## ASSESSMENT REPORT

### Glendell Coal Mine – Transmission Line Relocation (DA 80/952 MOD 3)

Figure 2: Proposed transmission line alignment

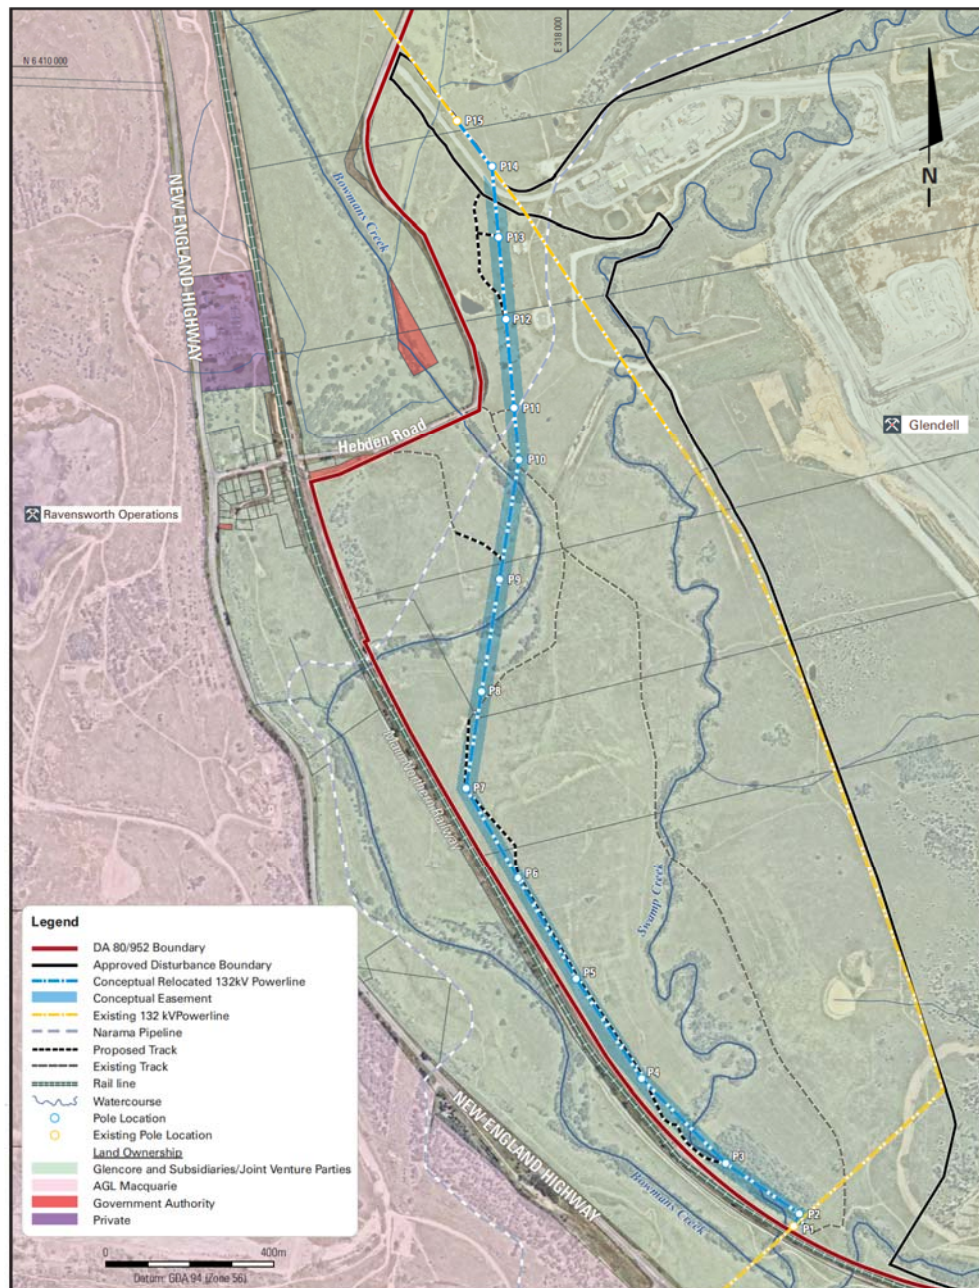
The proposed alignment for the new section of the transmission line is located on land owned and managed by Glencore and is within the consent boundary, but outside of the currently approved disturbance boundary for the Glendell Mine (see **Figure 2**). The alignment generally runs north-south, parallel to the Narama Pipeline and crosses both Bowmans Creek and Swamp Creek on two occasions.

The alignment was selected in consultation with Ausgrid. In addition to geotechnical requirements and powerline design standards, the proposed alignment considered and endeavoured, where possible, to avoid:

- identified mineable coal reserves and potential future mining areas;
- Bowmans Creek, Swamp Creek and associated waterfront land;
- sensitive archaeology areas and heritage items;
- native vegetation; and
- existing infrastructure (eg New England Highway, Main Northern Railway and the Narama Pipeline).

Ausgrid requested additional information be provided on the suitability of the proposed right of ways (access tracks) and their impact on Swamp Creek, as well as the appropriateness of the proposed pole locations in proximity to Bowmans Creek and Swamp Creek. In the RTS, Glencore provided additional justification for the pole locations and revised the proposed access tracks to ensure 24/7 all-weather access. Following review of the RTS, Ausgrid made no further comment on the positioning of the proposed infrastructure. The Department understands that Glencore would continue to liaise with Ausgrid on the final design of the transmission line and has proposed a condition of consent to ensure the transmission line is designed and constructed to the satisfaction of Ausgrid.

To facilitate the relocation of the transmission line the Department has proposed a new condition in Schedule 2 requiring Glencore to relocate the affected transmission line to a new alignment to the satisfaction of Ausgrid, prior to mining within 200 metres of the existing electrical transmission line. The Department has also proposed a new figure for the Development Layout Plan in Appendix 2 that shows the new conceptual alignment of the transmission line.
